# Access Compliance Report

## Public Rights-of-Way (Curb Ramps)

Intersection ID: 8030	Main Street: RUTGERS_AV	Cross Street: W_SUGAR_CREEK_RD	Location: NW
ADA ID: 496D6BF2AC6D	Ramp Type: Para	Initial Pass/Fail: Fail	Overall Compliance: No
Severity Score: 25			
Codes/Mitigation Info/Possible Solution		Field Measurements/Component Compliance

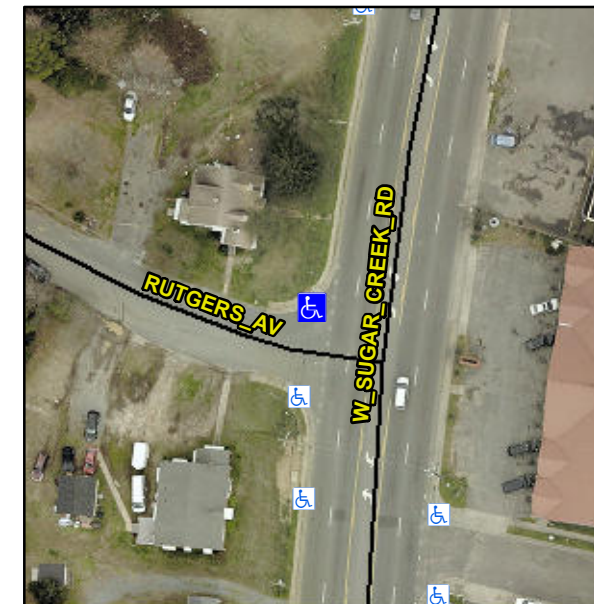
**LT RP < 5%**

**R304.3.2**

Compliance	Description	Data	Compliance	Description	Data
N/A	Ramp Length LT (in)	62.5	N/A	Ramp Length RT (in)	63.0
Yes	Ramp Width LT (in)	50.0	Yes	Ramp Width RT (in)	50.0
Yes	Ramp Slope LT (%)	0.3	No	Ramp Slope RT (%)	15.0
Yes	Ramp XSlope LT (%)	1.3	Yes	Ramp XSlope RT (%)	0.4
N/A	Landing Length (in)	N/A	N/A	DWS Provided?	N/A
N/A	Landing Width (in)	N/A	N/A	DWS Contrast?	N/A
N/A	Landing Slope (%)	N/A	N/A	DWS Length (in)	N/A
N/A	Landing X Slope (%)	N/A	N/A	DWS Full Width?	N/A
N/A	Landing Curb? (Y/N)	N/A	N/A	DWS Offset (in)	N/A
N/A	Shared Landing?	N/A			
N/A	Gutter Ponding?	N/A	N/A	Gutter Slope (%)	N/A
N/A	Gutter Lip Ht (in)	N/A	N/A	Gutter X Slope (%)	N/A
N/A	Painted X Walk1?	No	N/A	Painted X Walk2?	N/A
	X Walk 1 Direction	To S		X Walk 2 Direction	N/A
N/A	X Walk 1 Width (in)	N/A	N/A	X Walk 2 Width (in)	N/A
	X Walk 1 Slope (%)	0.0		X Walk 2 Slope (%)	N/A
	X Walk 1 X Slope (%)	5.0		X Walk 2 X Slope (%)	N/A
N/A	Ramp inside XWalk1?	N/A	N/A	Ramp inside XWalk2?	N/A

**Remove & Replace Entire Ramp.**
